#### **MEMORANDUM**

North Star Pit, 44485 Knight Drive Soldotna, Alaska

EPA File ID: AK122P5-30-13955 Injection Well Closure Plan 3 Pages + Attachments

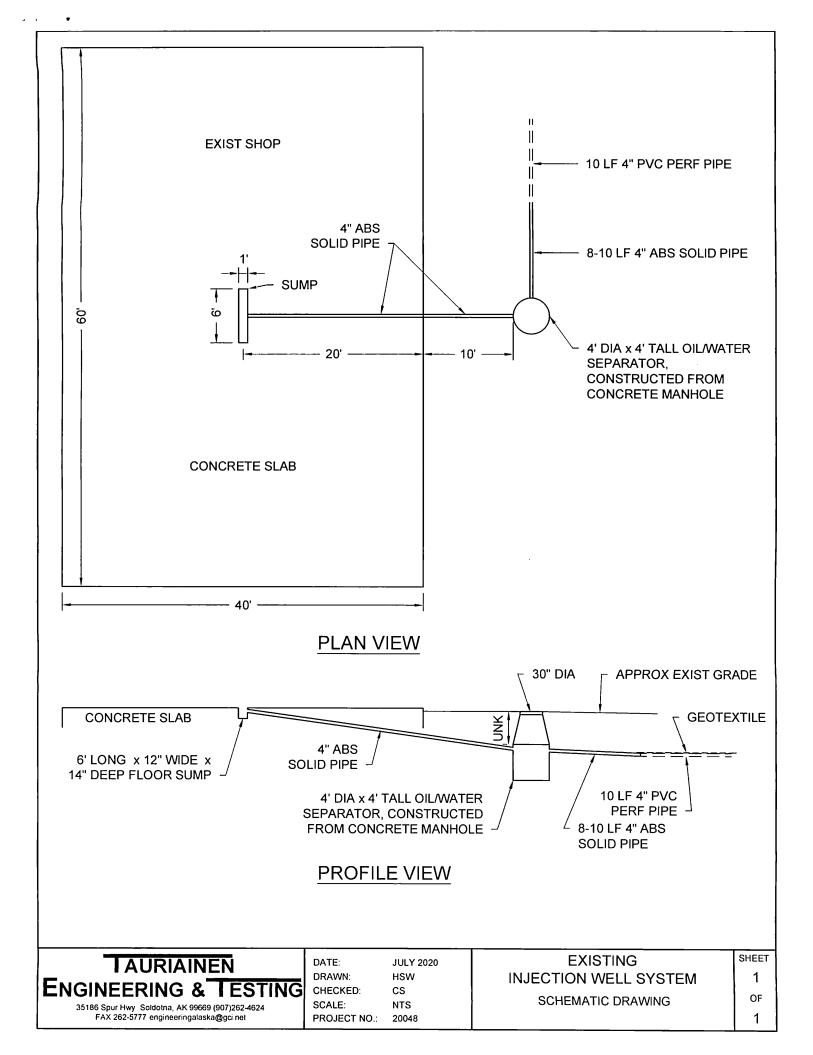
- 5) Please describe what alternative will be used for future wastewater (potentially used by new purchaser) given the automotive drains will remain within the shop. If it will become a dry shop (no washing of vehicles or floors), please state this and also clarify if this building has the potential for use as an automotive shop in the future. If the current floor drains are expected to become sumps which will be pumped out regularly and containerized and properly disposed, please state this as well. If the sanitary system is completely separate from the oil/water separator and leachfield, please note that in the work plan.

Subject welding and vehicle maintenance shop contains one floor drain. This floor drain consists of an approximately 6' long x 1' wide x 14" deep sump in the concrete floor with a 4" diameter ABS solid pipe exiting the sump sidewall. The 4" diameter ABS solid pipe is routed to the oil/water separator tank. See attached Existing Injection Well System Schematic Drawing for more information.

- 3. Piping will be capped upstream of the oil/water separator tank. Piping between floor drain and capped end will then be pumped full with concrete slurry. The existing sump in the concrete slab will remain (for future snow-melt catchment area), but concrete slurry will fill all piping (to flush with sidewall of sump) to prevent any future discharge from the sump.

Current and potential new owners anticipate no washing of vehicles or floors in the Shop. The Shop is planned to be utilized for welding only, and not automotive services. The floor sump, which will remain, will be pumped out as necessary, with pumped fluids containerized and properly disposed of.
